MFN 06-268

**Subject: Response to Portion of NRC Request for Additional Information
Letter No. 43 Related to ESBWR Design Certification Application –
ESBWR Containment Design and Probabilistic Risk Assessment Re:
Containment Fragility Analysis – (Release A) RAI Numbers 6.2-95,
6.2-97, 19.2-41, 19.2-44 to 19.2-46, 19.2-49, 19.2-50 and 19.2-57**

**Partial Response to NRC RAIs 6.2 and 19.2 Release A
RAI 6.2-95, -97. 19.2-41, -44,-45, -46, -49, -50 and -57**

Figure 6.2-95(1). Nodal Locations

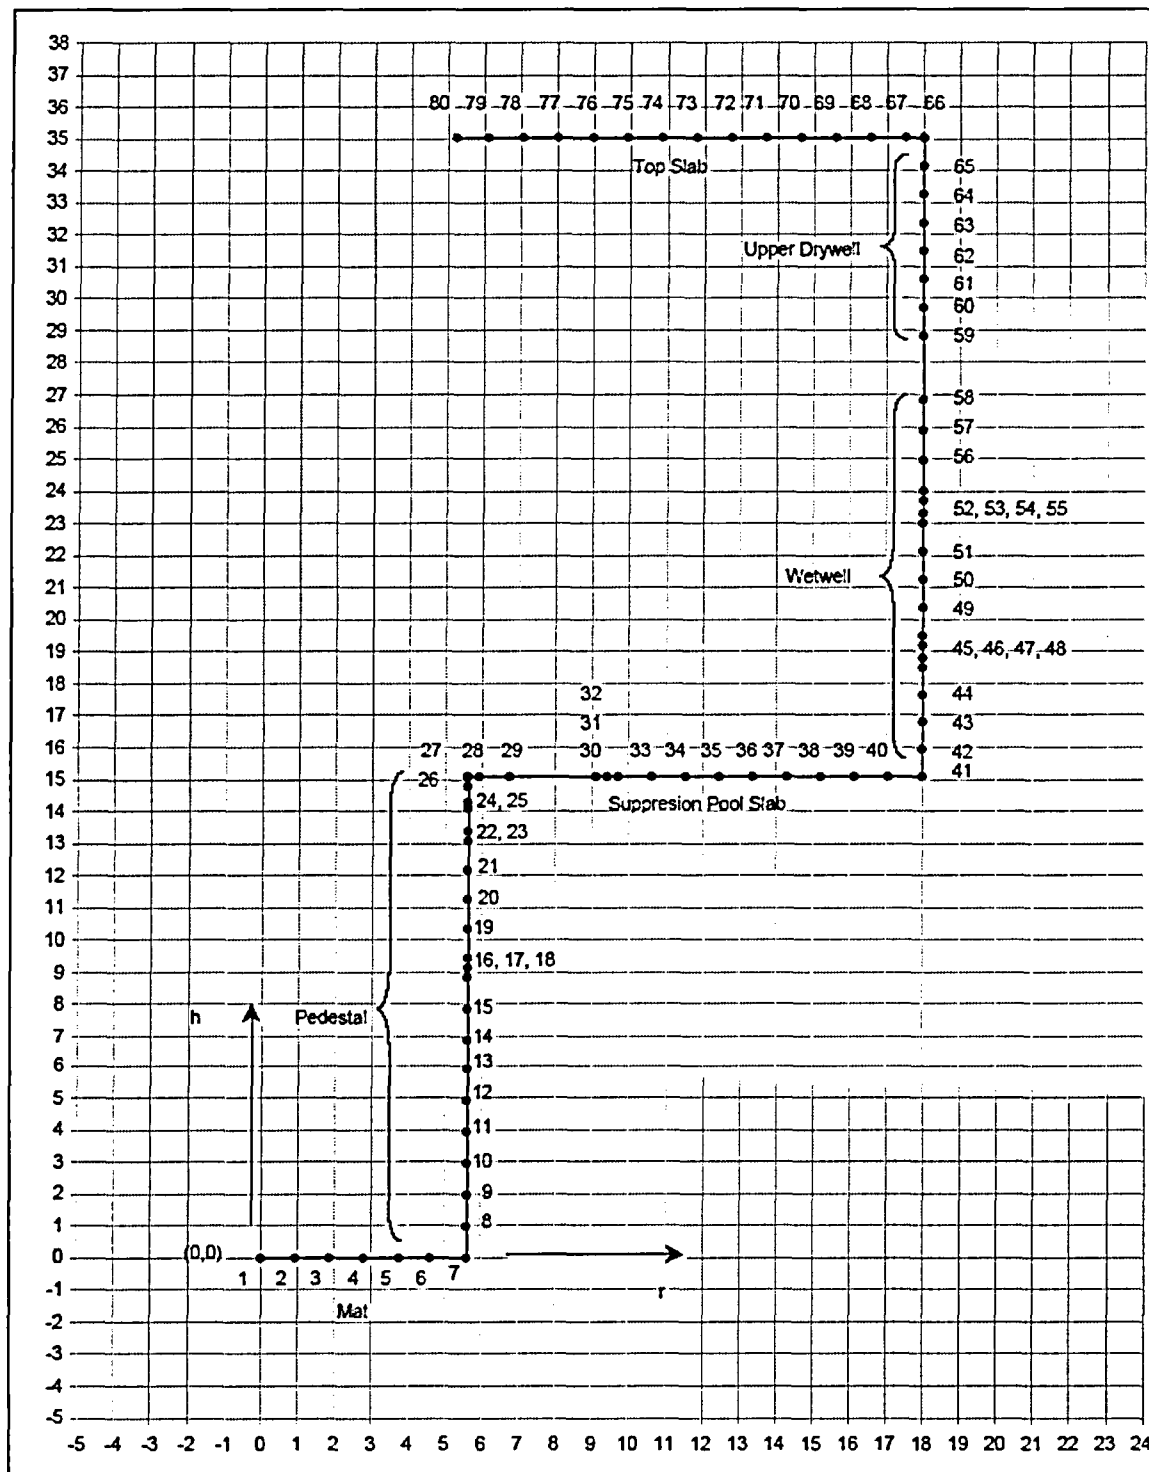
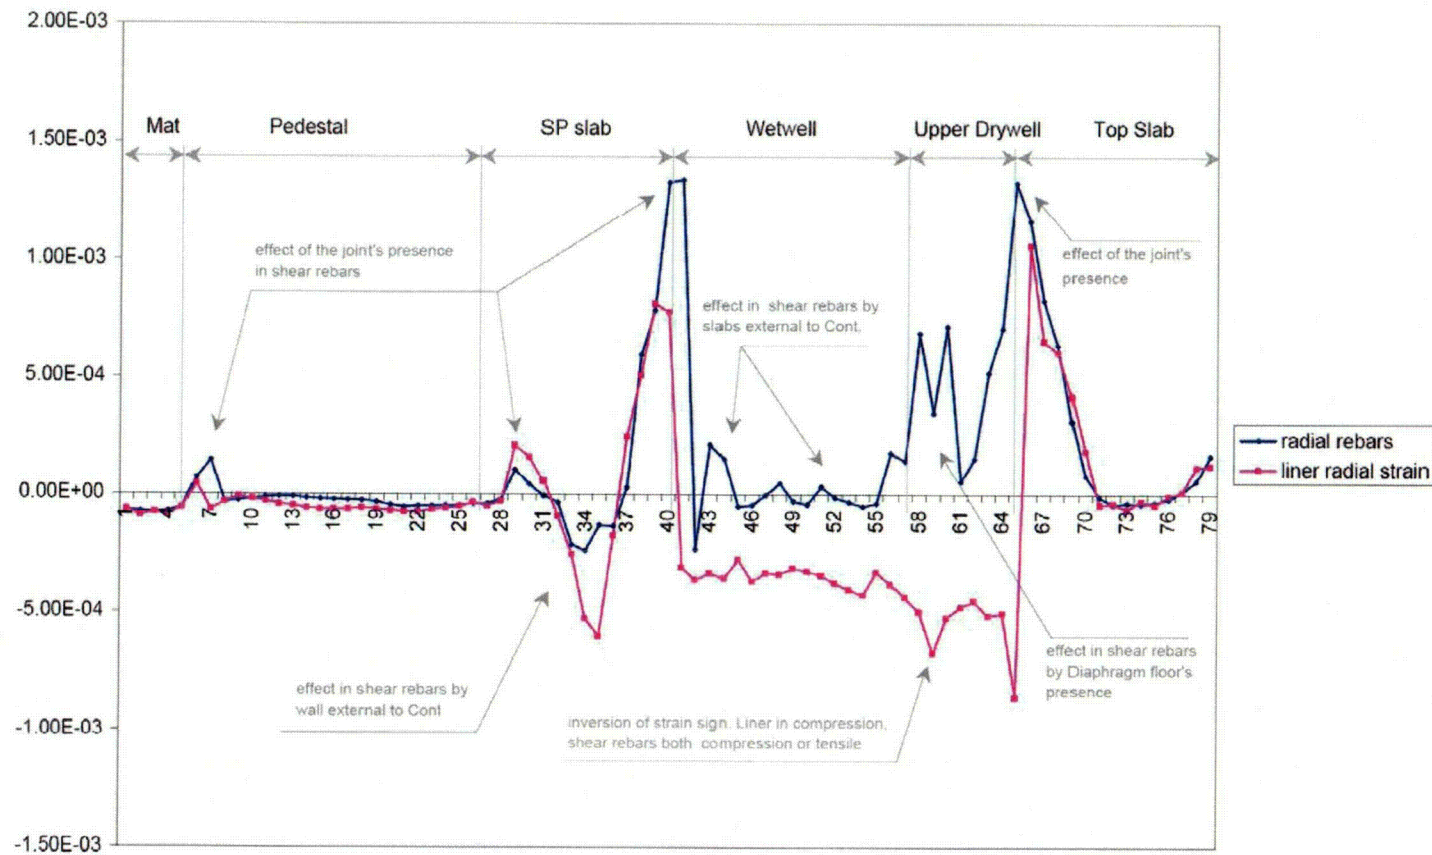
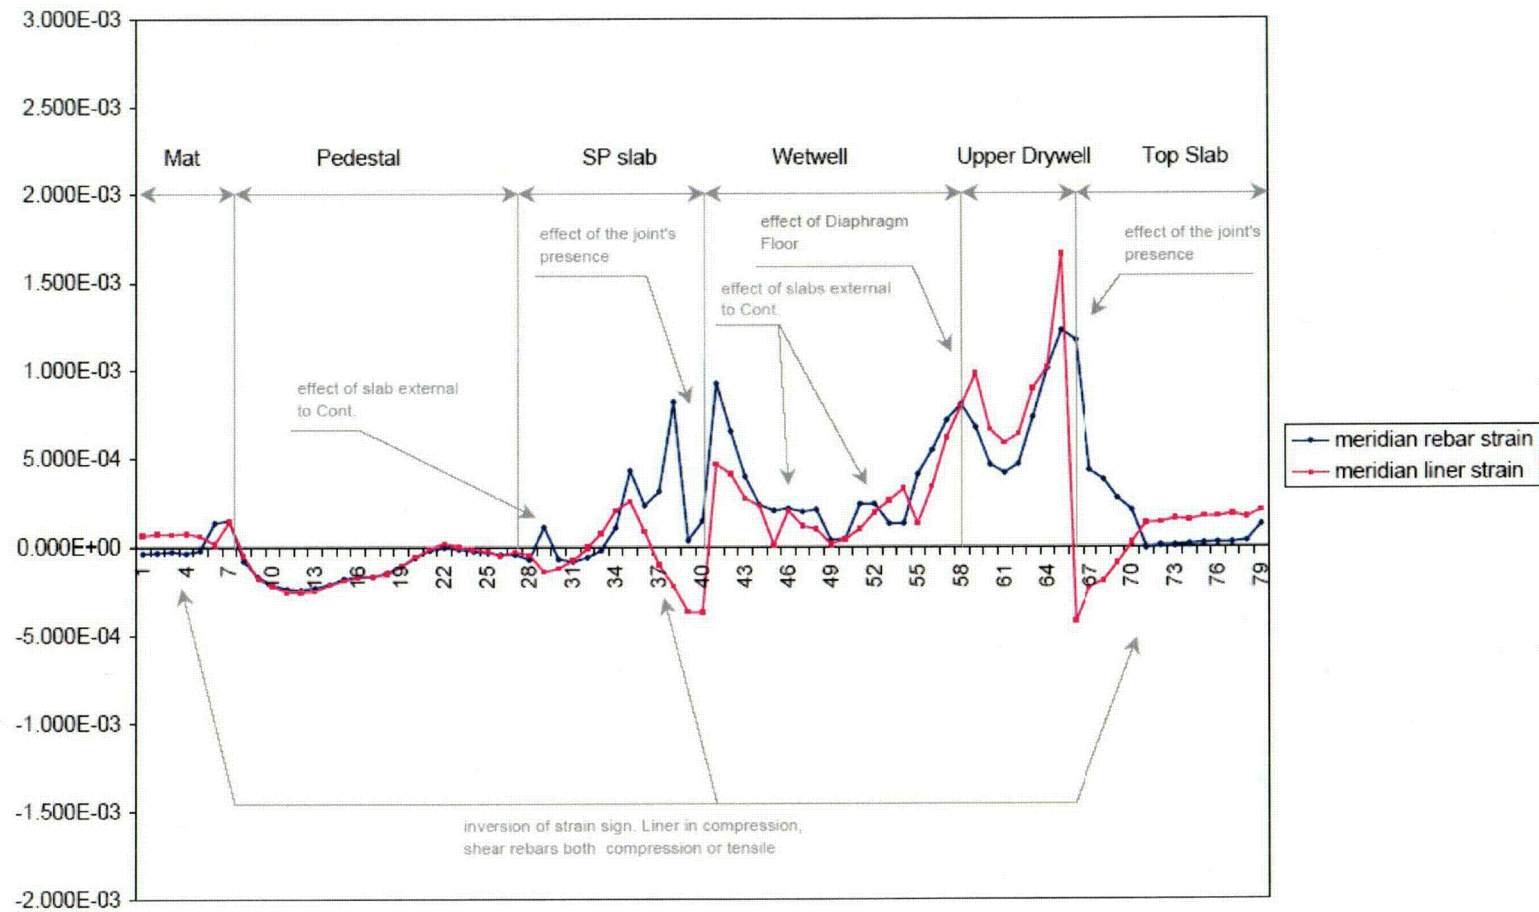
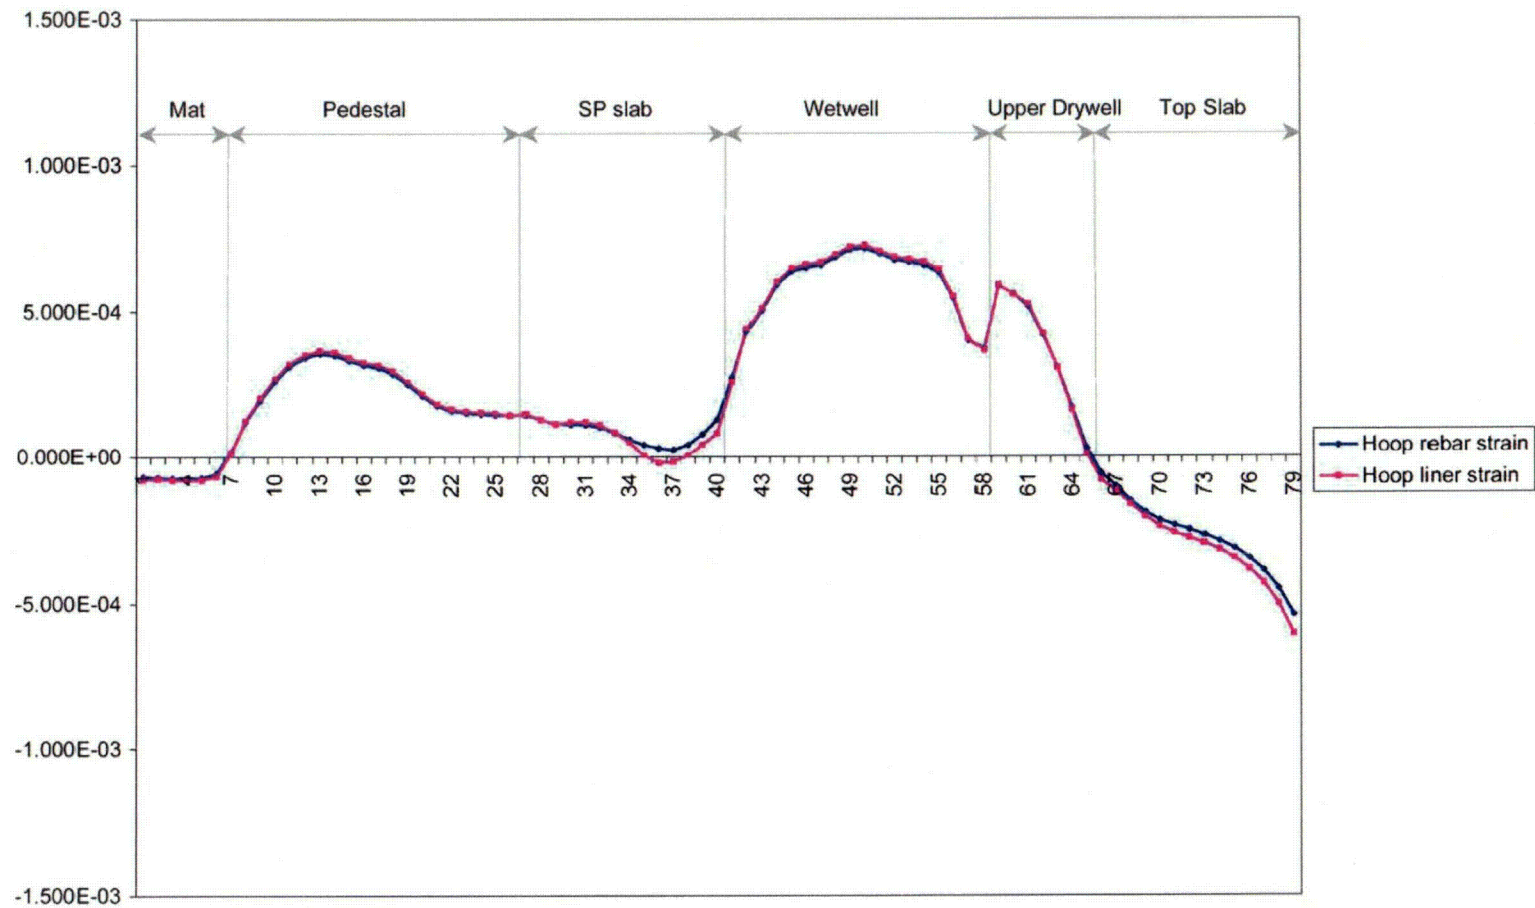
- a) Comparison of the concrete and rebar stresses to their factored load allowables.*
- b) Of the liner, concrete, and rebar, which limits the Level C pressure capability of the concrete containment (ignoring the steel penetrations)?*
- c) Compare the rebar strains to the liner strains at the 1.468 MPa load level. Explain any significant differences between the two.*
- d) The spacing between the anchors for the liner plate, including drawings to show how the liner is anchored into the concrete.*
- e) Locations (typical) of the heat affected zone at the liner weld seams and the proximity to liner anchors.*

- c) Figures 6.2-95(2), (3) and (4) show a comparison of the liner strains and rebar strains for concrete elements in contact with the liner in the radial, meridian and hoop directions, respectively, along the nodes shown in Figure 6.2-95(1). There are no significant differences between them if the rebars belong to a plane parallel to that of the liner. The comparison of the vertical shear rebar strains to the vertical liner strains (mat, SP slab or Top Slab), as well as of the radial shear rebar strains to the radial liner strains (Pedestal, Wetwell or Drywell) shows some differences. The explanation lies in how the load is being resisted, mainly, by bending and shear of

those structural elements. The shear stress distribution in shear rebars is therefore slightly different from that of the liner

Accordingly, the liner is mostly compressed in those areas, whereas the rebars can be under tensile or compression stress.

Other effects such as the proximity to the joint between structural members, as well as the presence of slabs, cause additional local differences. Note that, in spite of the differences, all rebar and liner strains are of the same order.

As for the hoop strain comparison, since none of the previous factors are present, liner and rebar deform in a consistent manner, such that there are not significant differences between them.

Figure Att. 19.2-44(1) ANSYS Solid65 element geometry

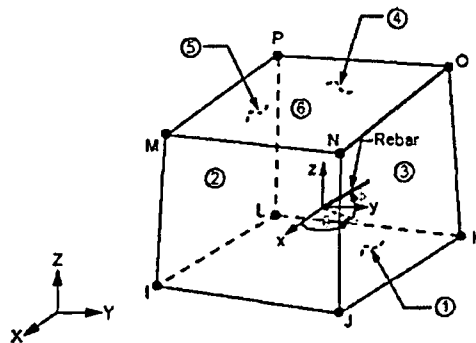
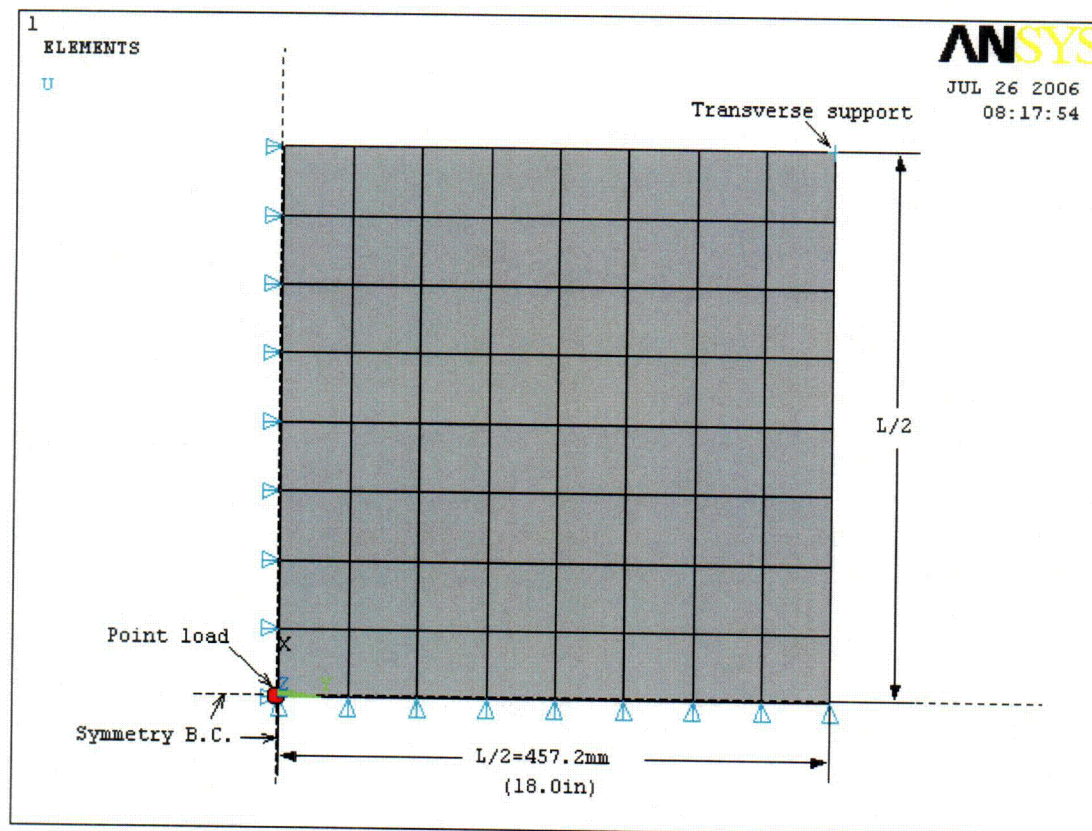
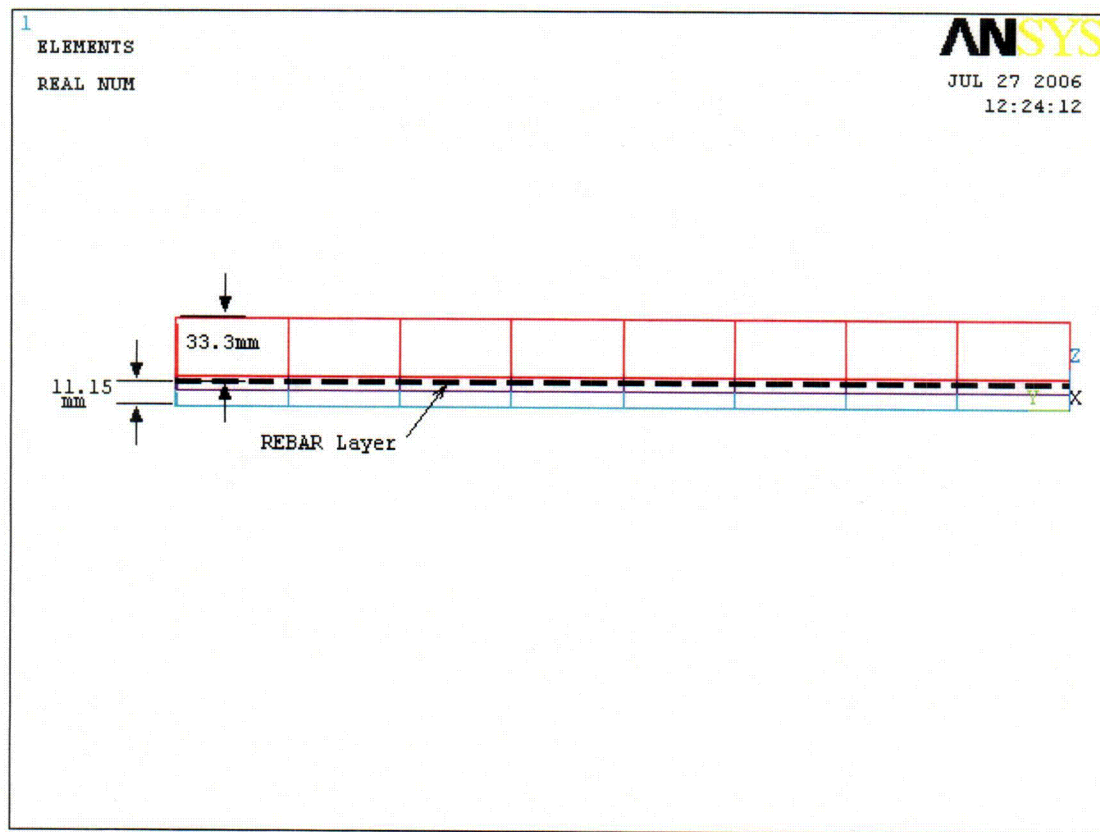
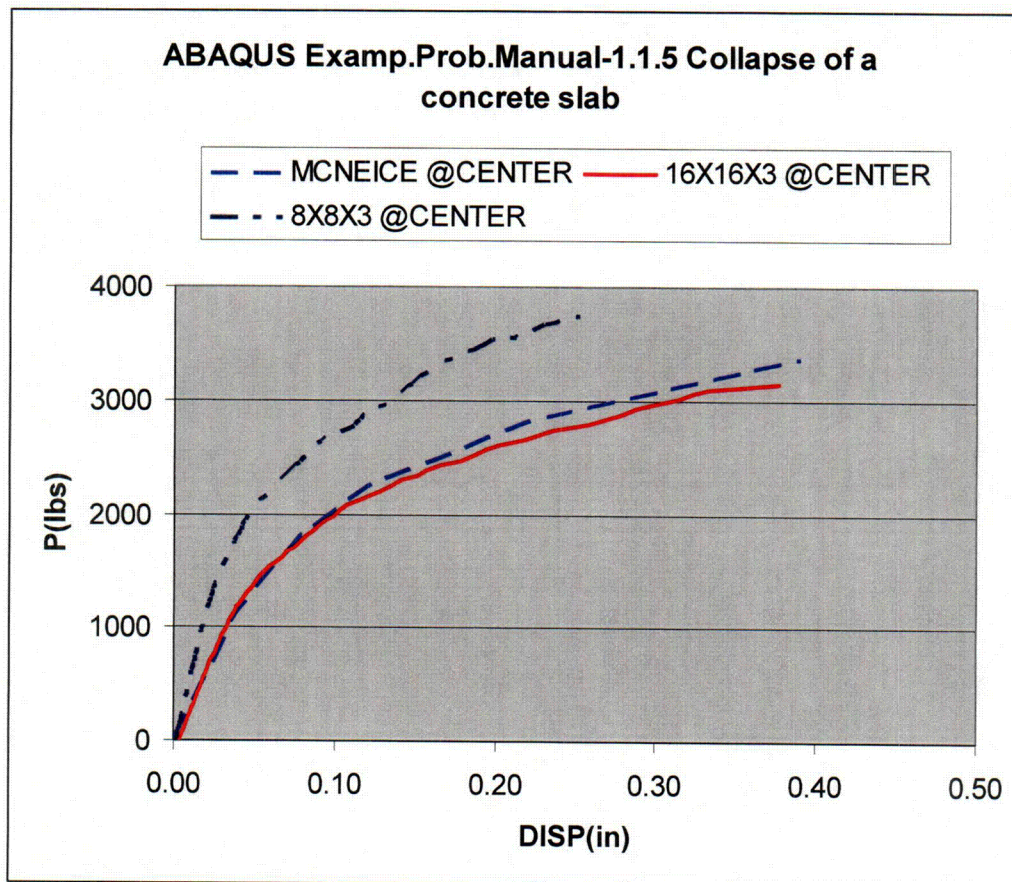
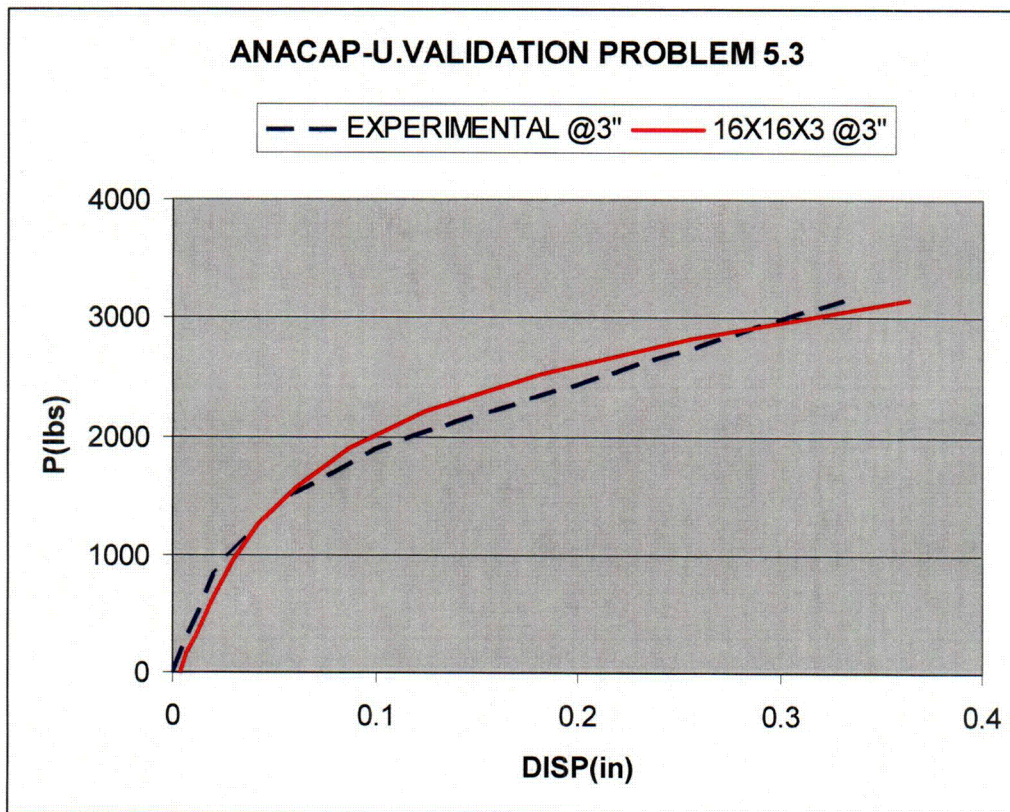
- c) the validation of the ANSYS reinforced concrete material model against other known commercial codes, such as ANACAP or ABAQUS, etc., on similar structures and loading, and their analysis comparisons;*

- c) A comparison between the ANSYS and ABAQUS computer programs for nonlinear calculations involving reinforced concrete is addressed in the attachment to this RAI.

Figure Att.19.2-44(4) shows the load-deflection curve at the centre of the McNeice slab and the ANSYS results for both 8x8x3 and 16x16x3 mesh models. A very good agreement is reached with the 16x16x3 mesh. The 8x8x3 mesh over-predicts the stiffness of the test model.

Figure Att. 19.2-44(5) shows the load-deflection curve at a 3" offset along symmetry axe from origin of the McNeice slab and the ANSYS results for 16x16x3 mesh model. Also a very good agreement is observed.
